Refer to: HNG-14

This is in response to your December 17, 1996, letter to Mr. Nicholas Artimovich requesting that the Federal Highway Administration (FHWA) accept your company's breakaway couplings for use in various support systems on the National Highway System (NHS). The couplings are ASTM A325 fasteners with special dimensional requirements (A325 breakaway couplings). Transmitted with your letter were three December 1996 reports of pendulum testing conducted by the Southwest Research Institute on single-post supports, a video of the tests, drawings of the hardware, and other documentation. Additional information and drawings were sent on March 19 in response to our request.

Geometric and Safety Design Group Acceptance Letter SS-60B rev

Figure 2. Type A-LP Break Away Connector

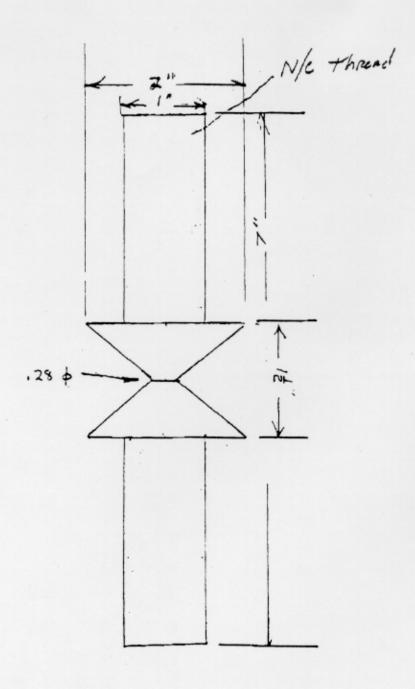
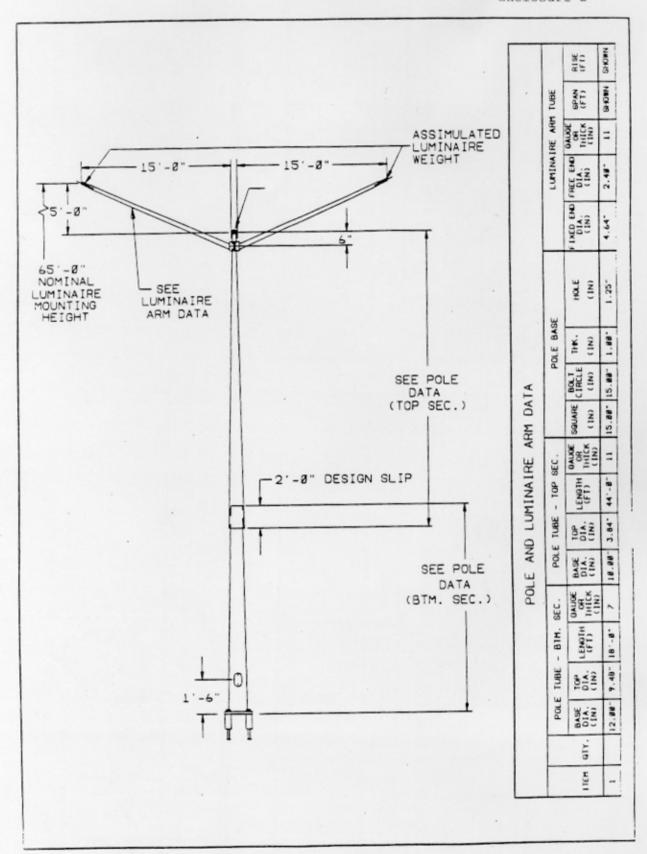
LP-1: The Type A-LP A325 breakaway coupling was a 1-inch (25.4-mm) diameter galvanized device (see Enclosure 1) used to attach the luminaire pole base plate to a foundation plate in the test fixture (see Enclosure 2) The pole base plate was a conventional non-breakaway four-bolt design.

Because the results of the pendulum testing and the high-speed extrapolations met the stub height and change-in-velocity criteria recognized by the FHWA, your company's A325 breakaway couplings with 0.280-inch (7.11-mm) necked down breakaway cross sections will be acceptable for use on the NHS, in the range of conditions tested, when proposed by a State. The following limitations and conditions also apply:

- Maximum bolt circle diameter is 381 mm (15 inches).
- Maximum diameter at the grooved section is 7.11 mm.
- No more than one support is permitted in a 2.1-meter path.
- All supports shall be mounted to a structural concrete foundation that will not move in the soil if the support is struck by a vehicle.

Enclosure 3A

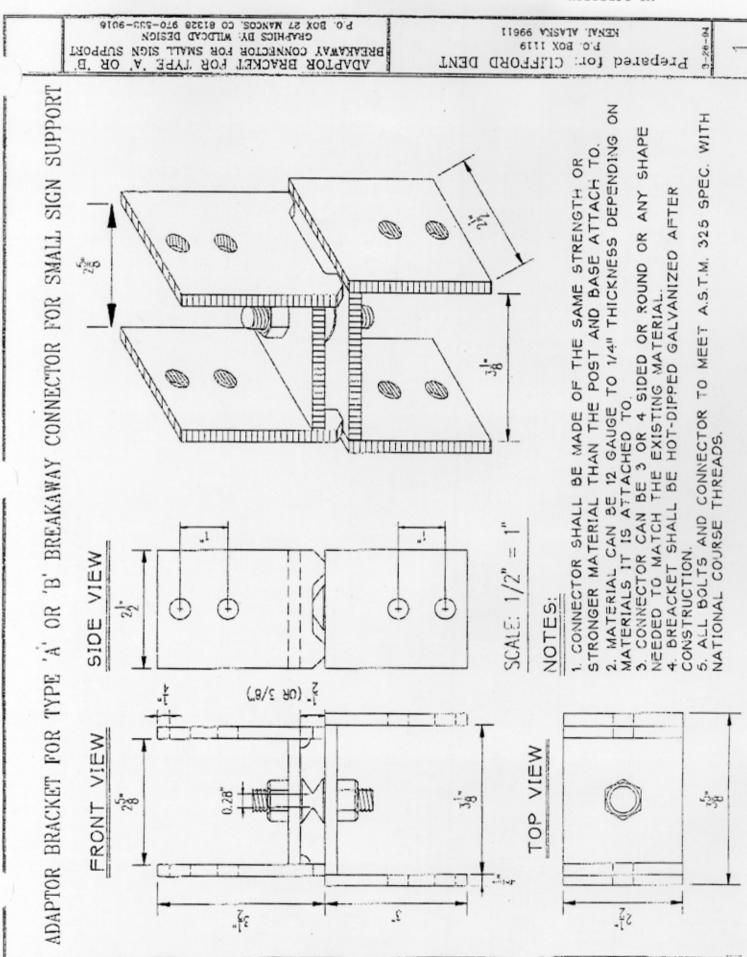
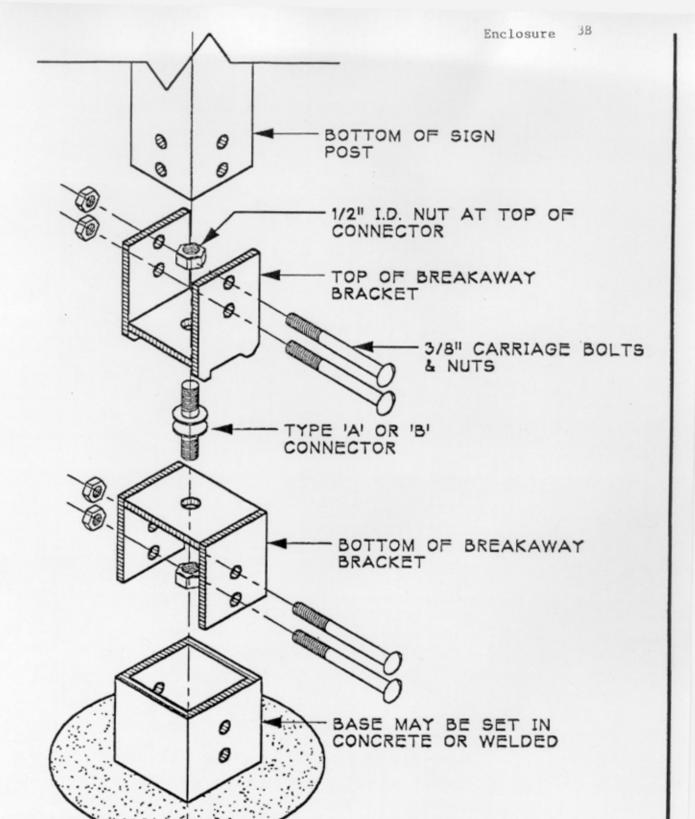
SP-1: The test article consisted of 3700-mm long by 64-mm perforated square steel tubing (12-gage wall, grade 50 steel.) The tube was bolted to a ground to pole adapter bracket (see Enclosures 3 A and 3B) using two 3/8-inch (9.5-mm) diameter carriage bolts. The bracket was bolted (using 3/8-inch carriage bolts) to a section of 76.2-mm square steel tube that was welded to the test fixture. One 1/2-inch (12.7-mm) diameter galvanized A325 breakaway coupling (see Enclosure 4) was used in the ground to pole adapter bracket.

You also requested that the bracket tested for square tubes in test SP-1 be accepted whether the size of the post fits inside or outside the upper portion of the bracket. This variation is acceptable as long as the posts are at least as stiff as the tested 12-gage 64-mm square perforated tube. The section modulus of the tested tube (10, 520 mm³) may be used when comparing other post sections. Posts with lesser section properties should not be used unless verified by crash testing.
